CALC TITLE <u>ADEQUACY OF CONTROL ROOM AIR INTAKE MISSILE SHIELDS TO PROTECT CHILLED WATER EXPANSION TANKS.</u>	CALC NO. <b>DC03380-001</b>	REV <b>1</b>	STAT <b>A</b>
---	--------------------------------	-----------------	------------------

CONTENT DESCRIPTION:  SEE REVISION DETERMINE ADEQUACY OF EXISTING CONTROL ROOM AIR INTAKE MISSILE SHIELDS FOR SHIELDING CHILLED WATER SYSTEM EXPANSION TANKS XTK-174A,B-VU.

Project Title DC03380-001, REV 1 VERIFICATION Tab 4.27 Page 1 of 1

PLAN VIEW  
(REF E-414-401 REV 8)

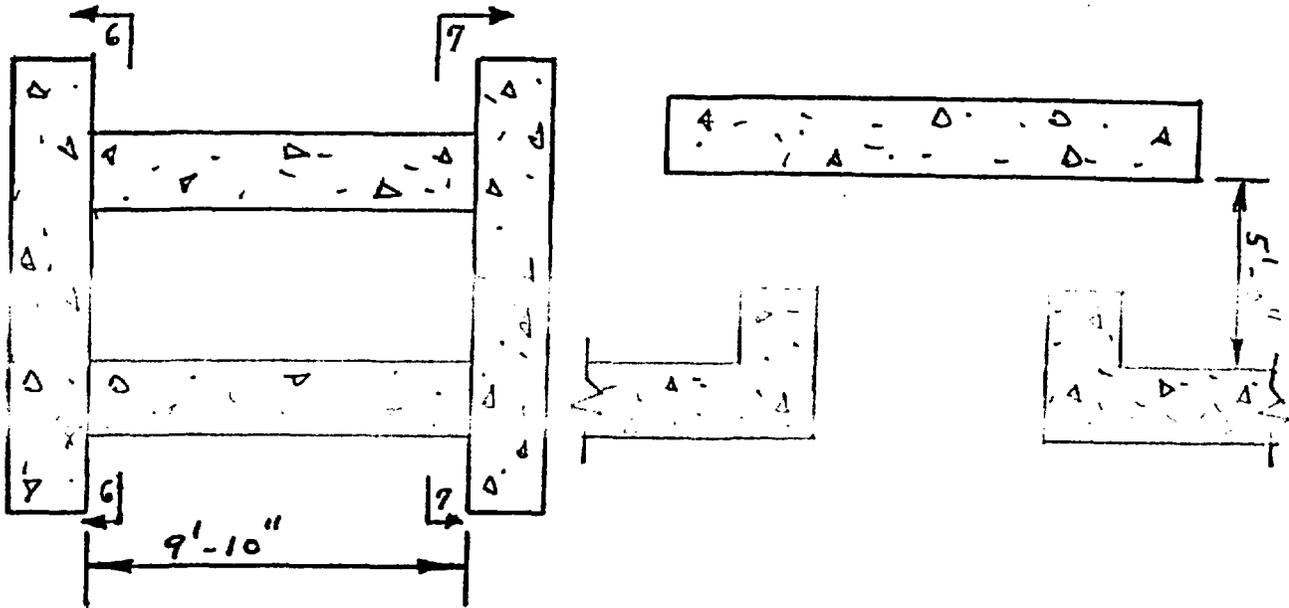
The design inputs (location of XTK0174A,B-VU and dimensions of the affected air intake missile shield) are correctly taken from MRF 22114 and E-414-401, Rev 8 and E-414-403, Rev 3.
